# Detailed Site Plan Aspen Maryland

## DSP-20031

REQUEST	STAFF RECOMMENDATION
Two mixed-use buildings with a total of 129 multifamily dwelling units and 2,080 square feet of ground floor commercial space.	APPROVAL with conditions

STAFF REPORT

*Figure 15: Building Form exhibit from the Central US 1 Corridor Sector Plan*

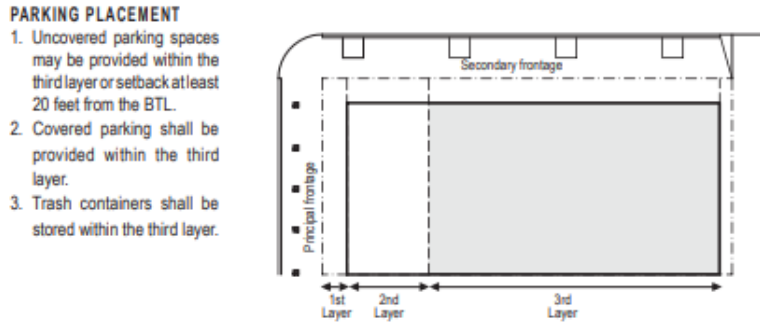
- a. **Page 234-Building Form/Parking:** In the Walkable Node, covered parking shall be provided with the third layer (minimum 20 feet from the build-to-line). The second story of Building 1 includes structured parking that is within the second layer and is within 20 feet of the build-to-line.

The applicant argues that only a portion of the covered parking is within the second layer, and the majority of parking provided in the garage is in the third layer. Furthermore, the applicant states that the proposed parking is not a stand-alone parking structure, but rather has been integrated into the building’s design, and the parking is screened by the residential lobby and retail space at the street level and is screened by a wall on the second level of the parking garage. Due to these reasons and because the parking will generally be screened from the public realm, staff supports the amendment request given that proper architectural screening will block the view of cars and internal light fixtures, as conditioned herein. Therefore, staff recommends **approval** of this amendment.

**Figure 17: Section showing the height of Buildings 1 and 2**

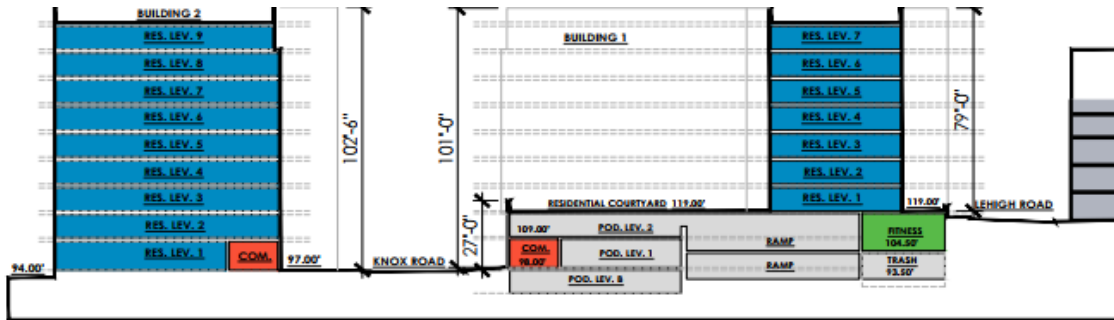
- b. **Page 234–Building Form/Character Area 5A/Walkable Nodes/Building Height:** To increase the height from the maximum six stories permitted in the Walkable Node to nine stories.

The proposed nine-story building height for Building 1 would conform to the Walkable Node (University) height provisions, however Building 1 is located in the Walkable Node and an amendment is required. The applicant justifies that the sector plan and County policies promote density at this location and that the amendment to allow a nine-story height will form a strong urban edge in close proximity to the University of Maryland campus. The topography of the site changes 20 feet from one end to the other, and the amendment to the height will allow a consistent building height along Knox Road. For these reasons, staff recommends **approval** of this amendment.

**SITE/BUILDING SECTION DIAGRAM 3**

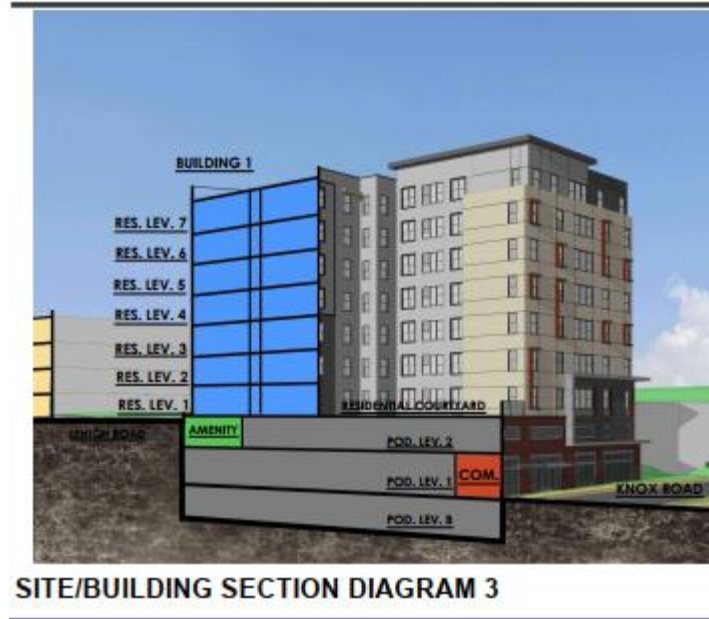
COMMENT: In the abundance of caution, the applicant is requesting a modification to the standard since the covered parking (which is covered, internal structured parking, and comprises of underground and podium parking) is technically, at the second podium level, in the second layer.

Within the Walkable Node Character Area, covered parking shall be provided in the third layer (minimum 20 feet from the building face). The applicant requests a modification to allow a portion of the proposed parking to be located within the second layer of the building, with the majority of parking provided in the third layer. The covered parking is not a stand-alone parking structure, but rather integrated into the building's design. The parking is fronted by the residential lobby and retail at the street level portion of the building (i.e., podium level 1), but at podium level 2 has five (5) spaces in the second layer that are directly behind the front wall. See below:
